## Responses to Horsley Comments 2 May 2022 Weston ZBA Meeting

#### **Responses to Garner Comments 2 May 2022 Weston ZBA Meeting**

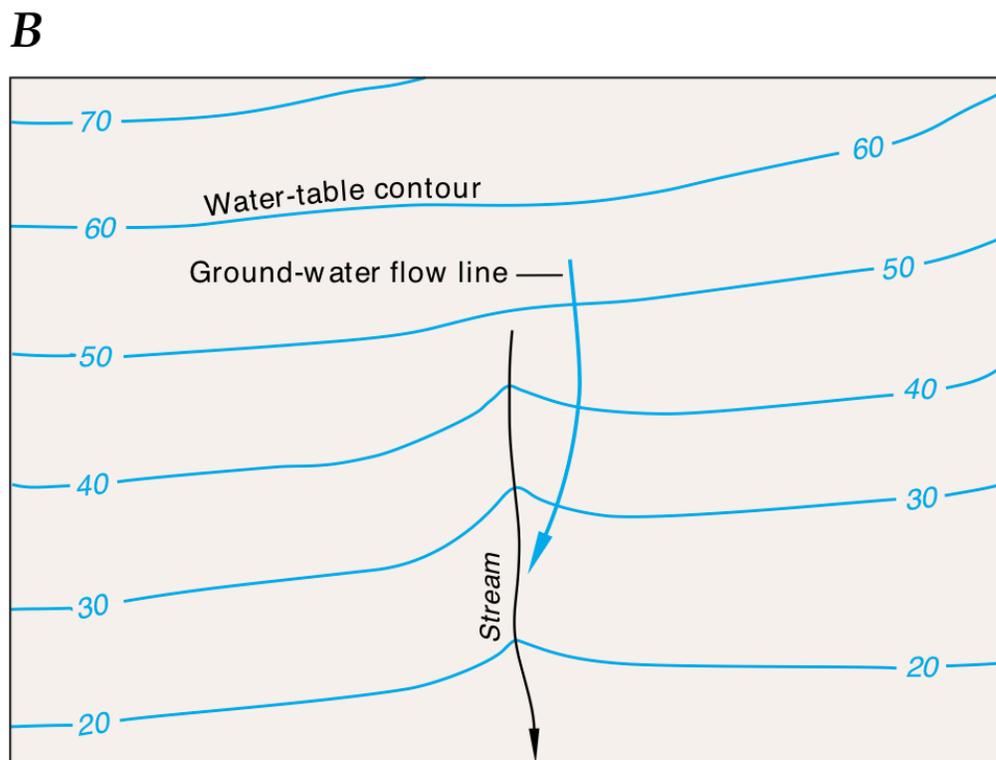
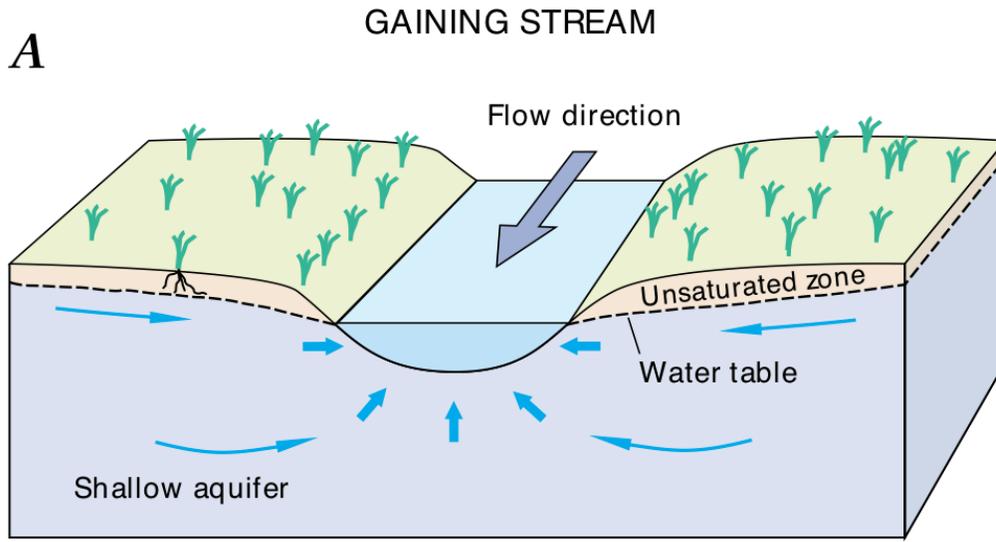
Mr. Horsley (slide 11) makes an oversimplification of the hydrology at the site to maintain that all infiltrated treated wastewater must flow to the intermittent stream. The basis of this premise is the following figure:

The problem here is that this figure does not depict the intermittent stream at the site but rather a perennial stream. As is common to many of Mr. Horsley's positions, he starts with a faulty assumption and builds his logic from there: the result is a faulty conclusion. Mr.

Horsley's oversimplification of the site hydrology is then used as the basis for estimates of the movement of contaminants. Intermittent streams may subscribe to this figure during certain times of the year: when the stream is flowing and during times outside of rainfall runoff events. When the intermittent stream is not flowing, the figure is completely in error. In particular Mr. Horsley believed that the water infiltrated from the applicants' infiltration basins had no other option than to flow to the stream, which of course cannot happen when the intermittent stream is dry: the fate of the infiltrated water when the intermittent stream is dry is to flow in a southeasterly direction with groundwater where offsite it may or may not flow into the stream. Obviously when the intermittent stream is dry, groundwater is not flowing into the stream, if it did, the stream would not be dry. As evidenced in Mr. Horsley's figure, away from the stream the groundwater contours clearly demonstrate groundwater flowing parallel to the stream. The intermittent stream resides on the sand and gravel on the east of the applicant's site, and both the stream and the sand and gravel continue south of the site. Therefore, contrary to Mr. Horsley's belief that all site infiltrated water must flow to the intermittent stream, the real fate for the infiltrated water is to move with groundwater both on and offsite, for a portion of it to be removed through evapotranspiration, and for some portion to discharge into the intermittent stream during periods when the stream is flowing.
